THIS SHEET SUPPLEMENTS ORIGINAL SHT C2 AND SHALL BE USED FOR THE CONSTRUCTION OF THE CLOUDED INFORMATION ONLY. BINKLEY BARFIELD SHALL BE RESPONSIBLE FOR ALL OTHER DESIGN INFORMATION SHOWN.

DESIGNED BY: TPJ  
 DRAWN BY: WSB  
 CHECKED BY: TPJ  
 DATE: 10.04.2019  
 SCALE: AS SHOWN  
 JOB NO.:  
 SHEET NO.: C2.1  
 OF 37

**PARK PLACE WEST - PHASE III**  
 R. BALLARD SURVEY ABSTRACT NO. 29  
 ROCKWALL, ROCKWALL COUNTY, TEXAS  
 PAVING PLAN & PROFILE  
 PARK PLACE BLVD

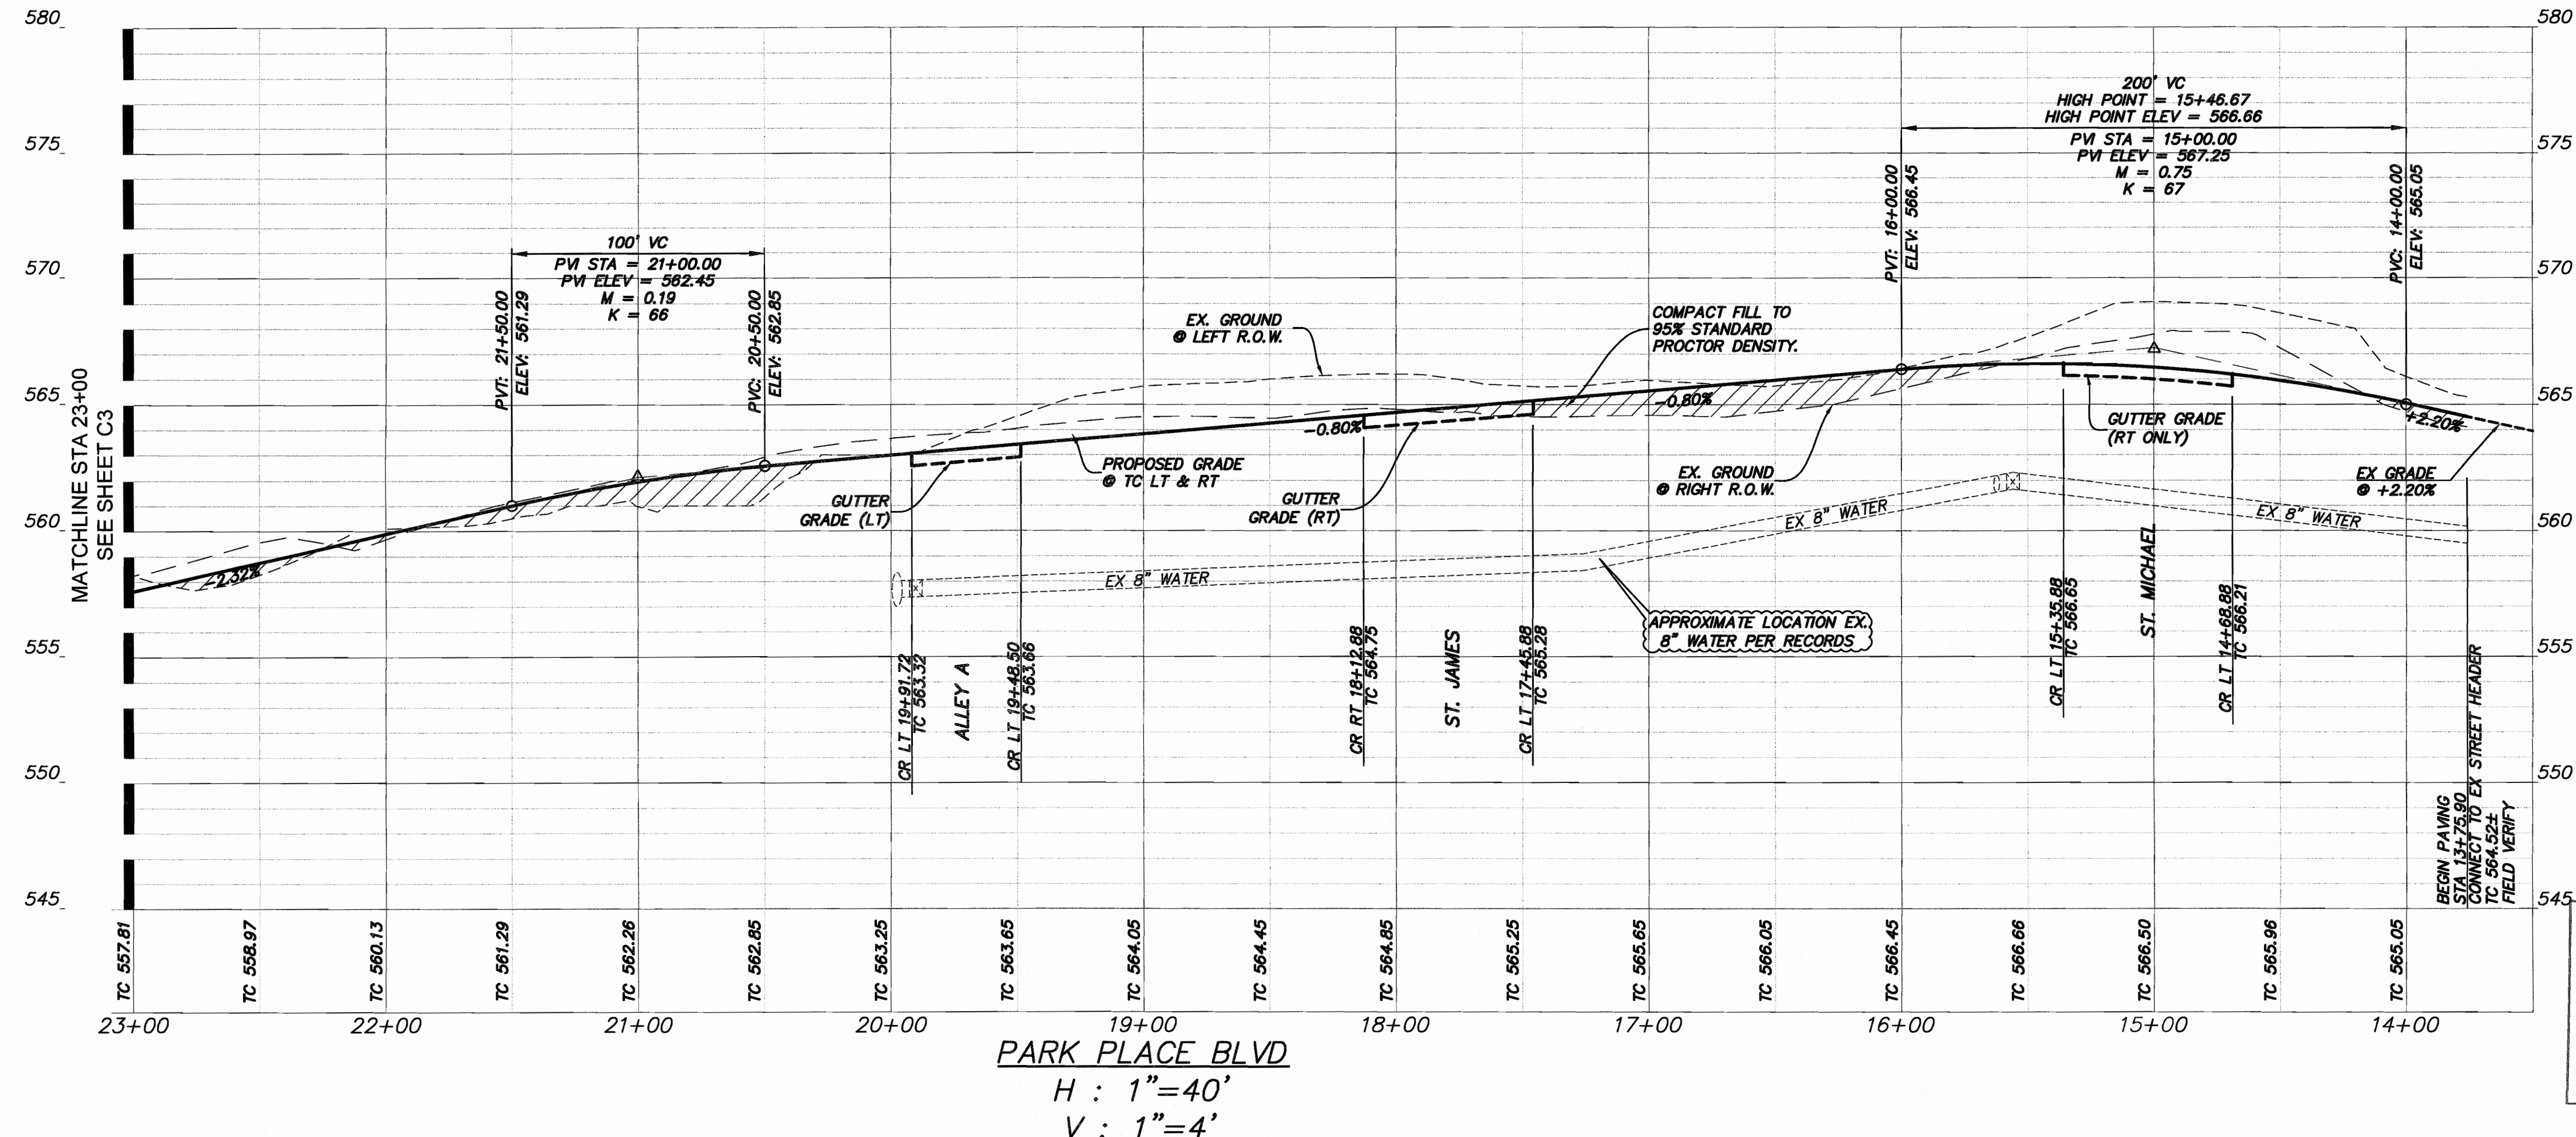
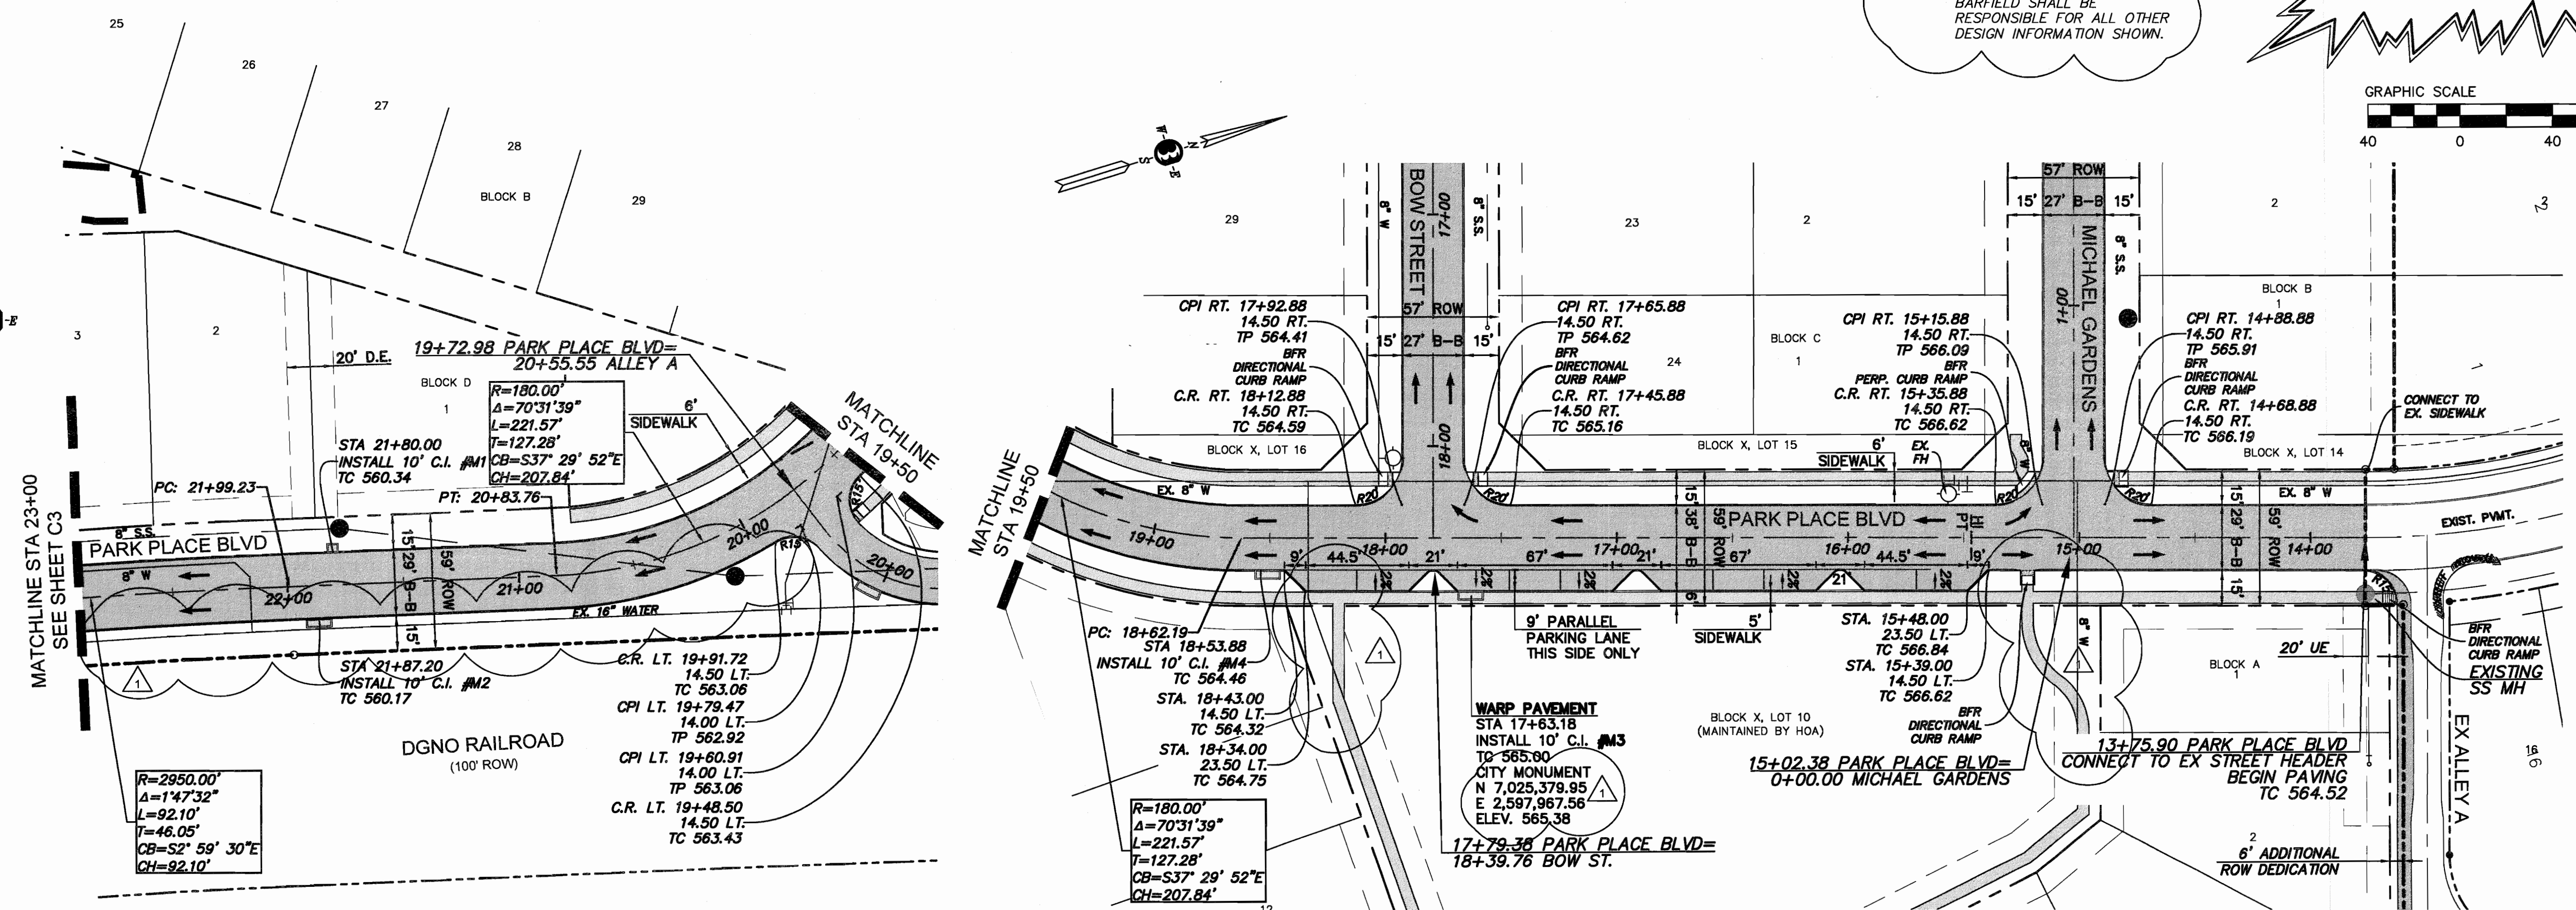
ADDED CITY MONUMENTS/ADJUSTED SIDEWALK
